NUMBER: 08-071-20

Interior Water Intrusion Through HVAC Air Inlet

2017 - 2018	(MP)	Jeep Compass
2017 - 2018	(M1)	Jeep Compass
2017 - 2018	(M4)	Jeep Compass
2018	(M6)	Jeep Compass

Fig. 4
New Stud Clips Installed on Headlamp Wiring Harness and Plenum Studs

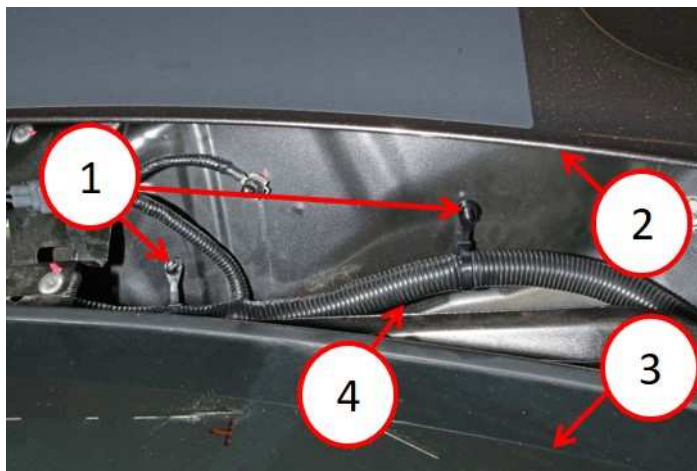
CAUTION! Both stud clips must be replaced. Failure to replace the clips may result in water intrusion through the HVAC air inlet.

4. Install two new stud clips onto the plenum studs and fasten the headlamp wiring harness (Fig. 4) .

- 1 - New Stud Clips on Plenum Studs
 - 2 - Vehicle Hood
 - 3 - Vehicle Windshield
 - 4 - New Headlamp Wiring Harness Routing (**Re-routing is accomplished when the new clips have been installed**)
-
